SUBMITTAL TRANSMITAL

PROJECT:	Harold Thompson Regiona	Submittal No: 05500-012			
	Birdsall Rd. Fountain, CO 80817 Job No. 2908				
ENGINEER:	GMS, Inc. 611 No. Weber St., #300 Colorado Springs, CO 8090 719-475-2935 Roger Sams	03			
OWNER:	Lower Fountain Metropolitan Sewage Disposal District 901 S. Santa Fe Ave. Fountain, CO 80817 719-382-5303 James Heckman				
CONTRACTOR:	NTRACTOR: CSM Industrial Contractors 614 Cliff Street Westcliffe, CO 81252 719-783-2867				
SUBJECT: Aeration	on Basin Splitter Structu	re			
SPEC SECTION:	05500 - Misc Metals				
PREVIOUS SUBMISSION DATES:					
DEVIATIONS FROM SPEC: YES _X_ NO					
CONTRACTOR'S STAMP: This submittal has been reviewed by Weaver Construction Management and, unless indicated otherwise, has been found to be in conformance with the intent of the contract documents.					
Contractor's Stam	p:	Engineer's Stamp:			
Date: 3/28/12					
Reviewed by: Tyler Ammerman					
() Reviewed With (X) Reviewed With

Project: HDTWRF Project

Submittal for: 05500-012 – Aeration Basin Splitter Structure Misc. Metals

Project	HAROLD D. THOMPSON REGIONAL	L	Date
	RECLAMATION FACILITY		3/26/2012
Area	LOWER FOUNTAIN METROPOLITAN		Drwn By
	SEWEGE DISPOSAL DISTRICT		DWN
Detail	DETAILS AERATION BASIN		Rev:
	SPLITTER STRUCTURE MISC. METALS		Date:
Dot Dw	Coolo	C

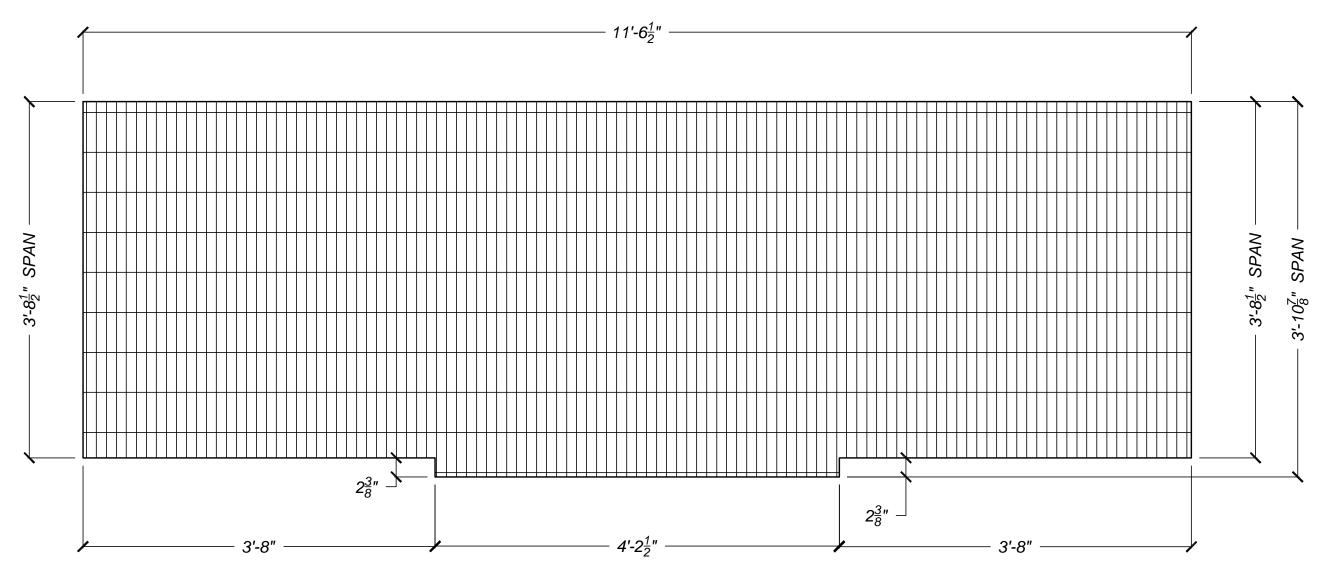
1. Openings in grating for slide gates will be field measured prior to fabrication of grating.

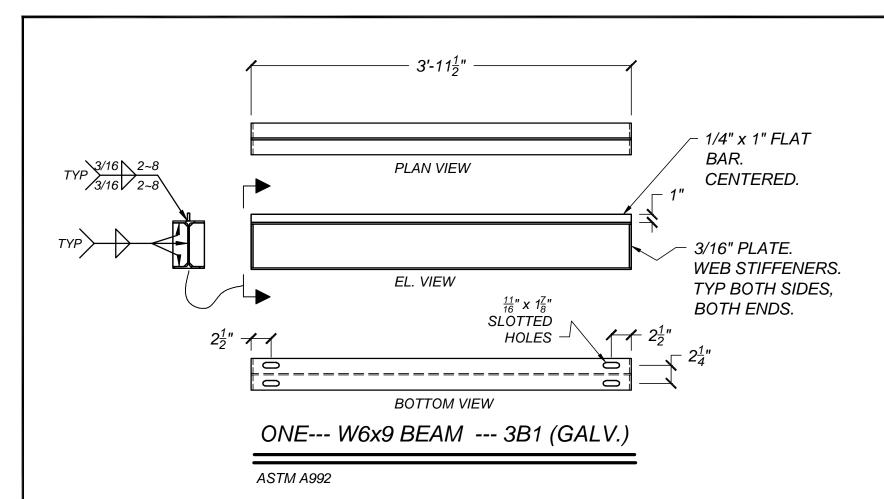
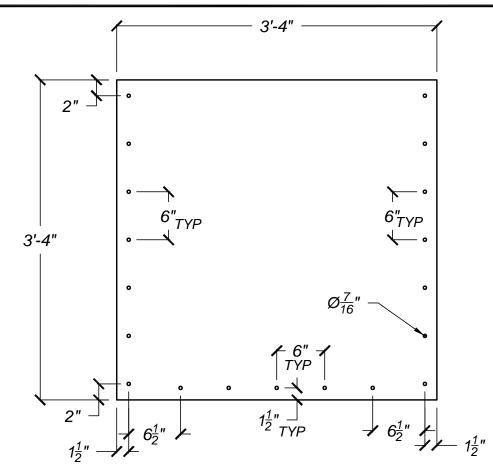
PLEASE VERIFY: SUPPORT BEAM 3B1, IS PER C/G-27. BEAM SIZE HAS BEEN INCREASED TO W6x9. W6x8.5 IS NOT A STOCK SIZE FROM THE SUPPLIER.
